Office Action Summary

10/754,391

SCHNEIDER, DANIEL H.

DETAILED ACTION

EXAMINERS FIGURE 1

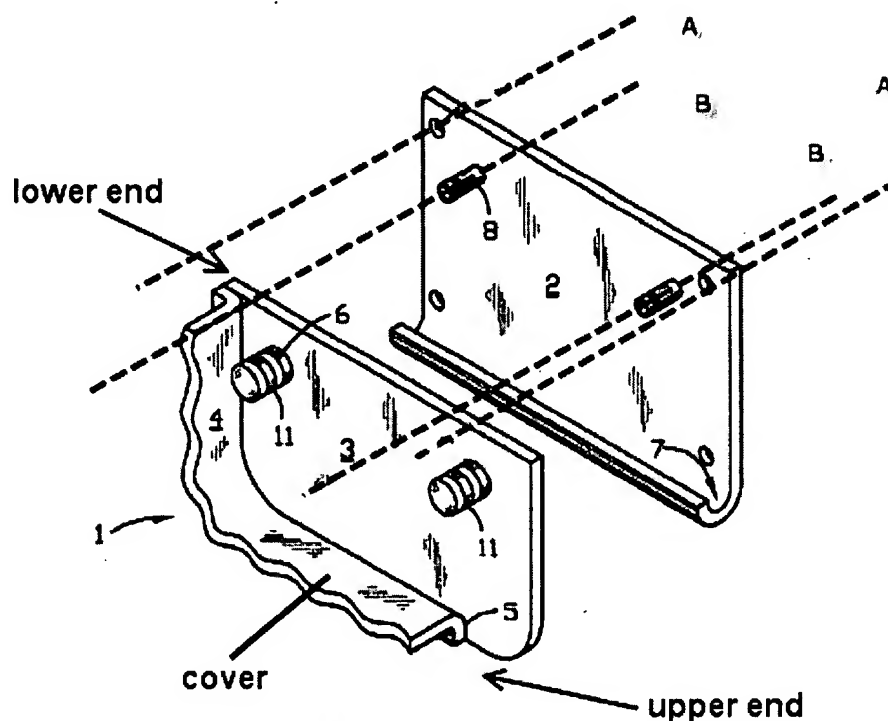
Regarding claims 1 and 8, Campbell discloses a saddlebag mounting system capable for use with a motorcycle having a fender support as claimed, including: a saddlebag 1 having (see Examiners Figure 1 below) a lower end and an upper end defining an upward direction, a cover being located at the upper end; a saddlebag frame 3 fixedly attached to the saddlebag; and a hook member at 5 integrally formed as part of the saddlebag, said hook adapted to couple a portion of the motorcycle and partially support the saddlebag; saddlebag frame 3 further includes first and second attachment members 6 configured to couple the saddlebag to a portion of the motorcycle; and

wherein the hook member at 5 is positioned above the positions of the first and second attachment members depending on how one looks at the figures, and furthermore wherein a central portion of the hook member at 5 is located between the attachment members.

Regarding claims 26 and 27, Campbell discloses a saddlebag mounting system essentially as claimed, including: a saddlebag 1 having (see Examiners Figure 1 below) a lower end and an upper end defining an upward direction, a cover being located at the upper end; a saddlebag frame 3 fixedly attached to the saddlebag; a hook member 5 integrally formed as part of the saddlebag said hook adapted to couple a portion of the motorcycle and partially support the saddlebag; first and second attachment members 8 spaced a distance from each other, the attachment members substantially inhibiting

movement of the saddlebag in any direction, including the upward direction when the saddlebag is coupled to the motorcycle, and wherein the hook member at 5 is positioned above the positions of the first and second attachment members depending on how one looks at the figures, and furthermore wherein a central portion of the hook member at 5 is located between the attachment members.

Regarding claim 17, the modified Campbell device discloses mounting axes (A in Figure 1 shown above) and attachment axes (B in Figure 1 shown above) in the claimed configuration including mounting axes through parallel spaced holes 10, and attachment axes oriented parallel each other and between said mounting axes.

Regarding the amended language of claims 1 and 26, they recite no structure that prevents a lower end, an upper end, and a cover from being defined as shown in Examiners Figure 1. It is not required that the saddlebag frame be specifically attached to the motorcycle in any orientation, rather that it be ***adapted*** to couple to a portion of the motorcycle. As such, one can simply flip the saddlebag frame 3 of Campbell upside down, and define an alternate upward direction that places the hook member 5 above the attachment members 6. Regarding the cover portion, no specific structure is recited in the claim as what is encompassed by the cover, and as such Examiner is considering the gusset portion 4 of the saddlebag to be a cover.

Examiners Figure 2

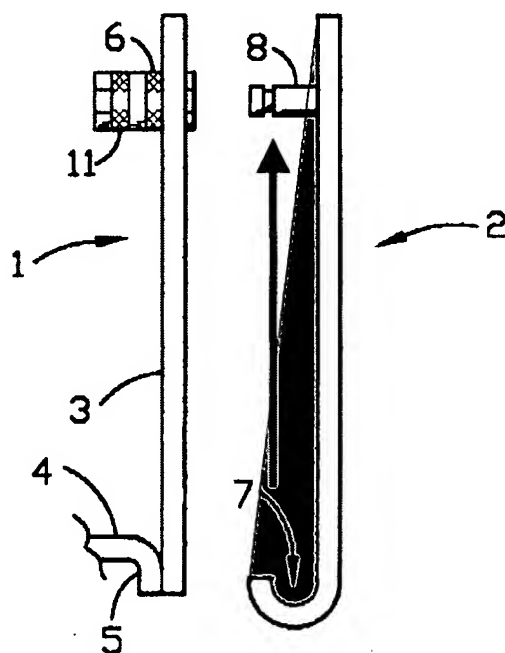
mount including bar member 2 having a cavity (shown in Examiners Figure 2 shaded in) formed within the lip 7, the cavity having an opening which can face in any number of directions, including away from the saddlebag and toward the fender support, and wherein first and second attachment members 8 of the bar are disposed within the bounds of cavity.

Regarding claim 18 the modified Campbell device discloses a saddlebag mounting system with saddlebag 1, a saddlebag mount including bar 2 extending along the motorcycle, and a saddlebag frame 3, which engages the bar and supports the saddlebag, wherein the bar defines a cavity (shown in Examiners Figure 2 shaded in) formed within the lip 7, the cavity having an opening which can face in any number of directions, including away from the saddlebag and toward the fender support, and wherein first and second attachment members 8 of the bar are disposed within the bounds of cavity.

Regarding the orientation of the cavity in claim 9 and 18, the cavity of Campbell as shown in Examiners Figure 2 is considered to face in any number of direction, including up and away from the saddlebag frame (as indicated by the arrow originating from the shaded area). Furthermore, claim 9 only requires that there be a saddlebag mount and a saddlebag frame which are engageable, but are not specifically connected.

As such, one could simple place the saddlebag frame 3 on the opposite side of the motorcycle as the saddlebag mount, such that the cavity faces away from the saddlebag and toward the fender support.
